**PLAN - DECHLORINATION SYSTEM**  
SCALE: 1/8" = 1'-0"

BAT ASSOCIATES, INC. ENGINEERS, SCIENTISTS, PLANNERS EUCLID, OHIO	
TITLE RAVENNA ARMY AMMUNITION PLANT DECHLORINATION SYSTEM GEORGE ROAD SEWAGE TREATMENT PLANT	
DRW:KAK ENGR:LDC CHKD:LDC DWG. NO. A-3794	DATE: 12/14/92 SCALE: AS NOTED SHEET 1 OF 4

**SECTION A**  
SCALE: HORIZ. 1/8" = 1'-0"  
VERT. 1/8" = 1'-0"

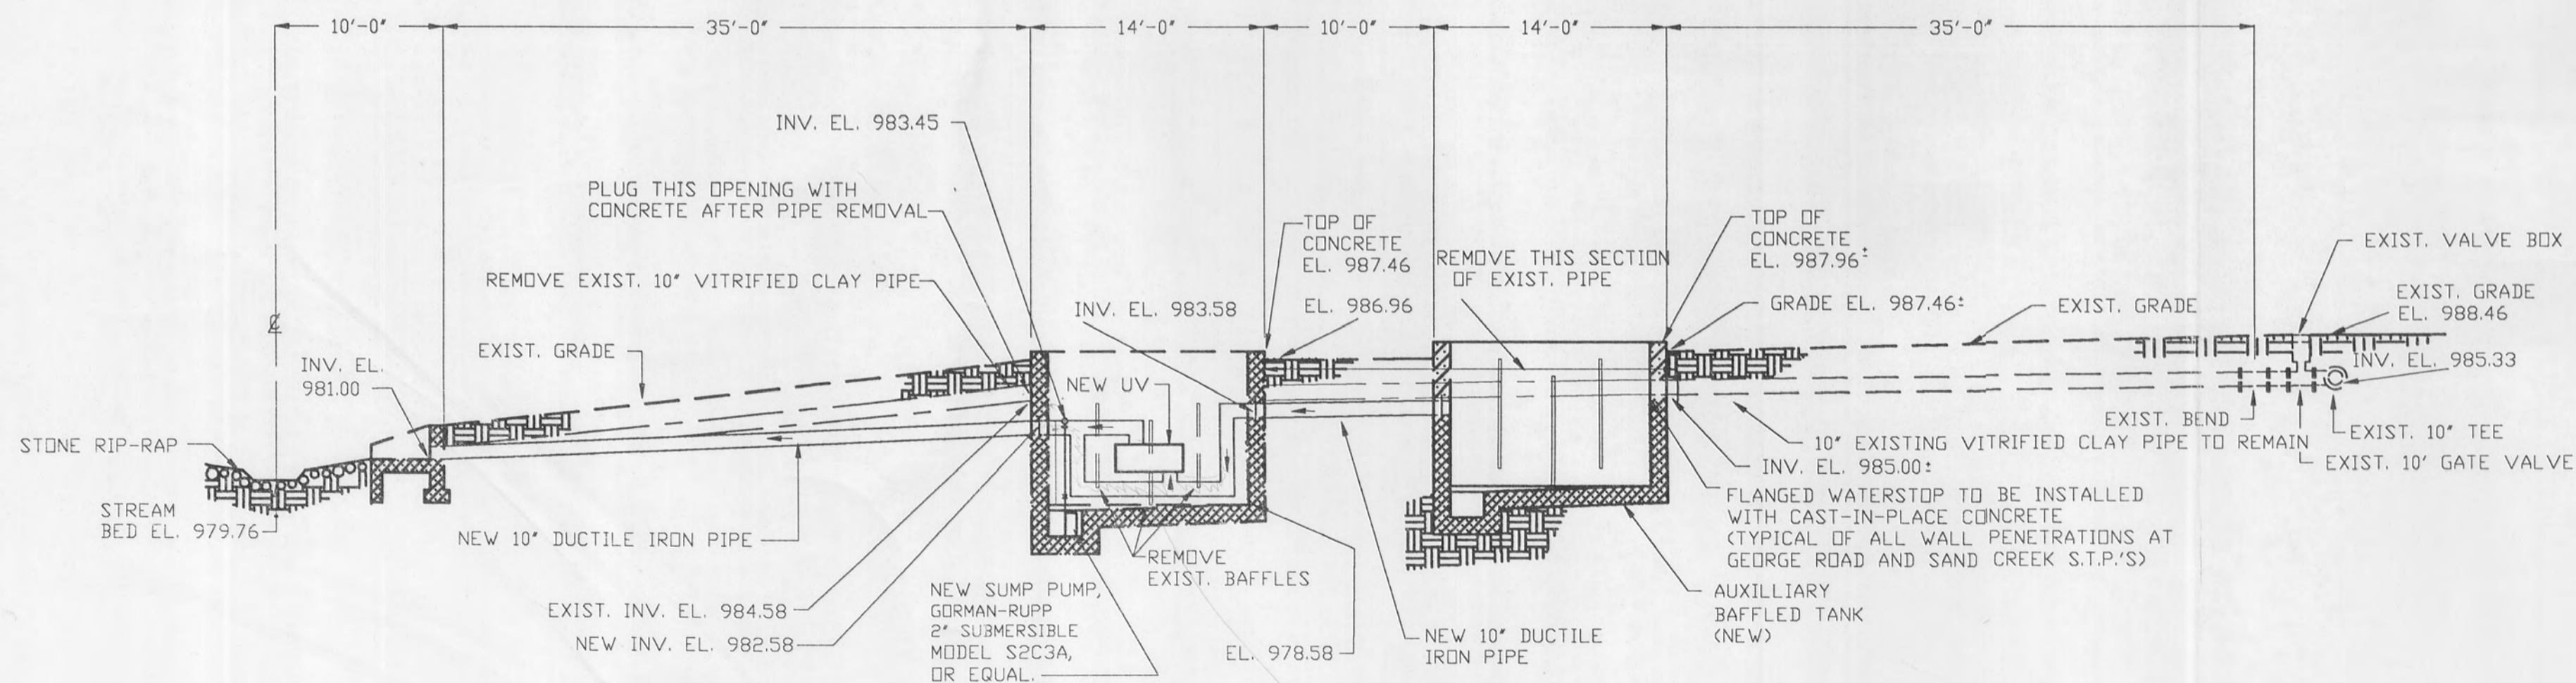
*will this be a way on bypassing the UV unit when disinfection is discontinued?*
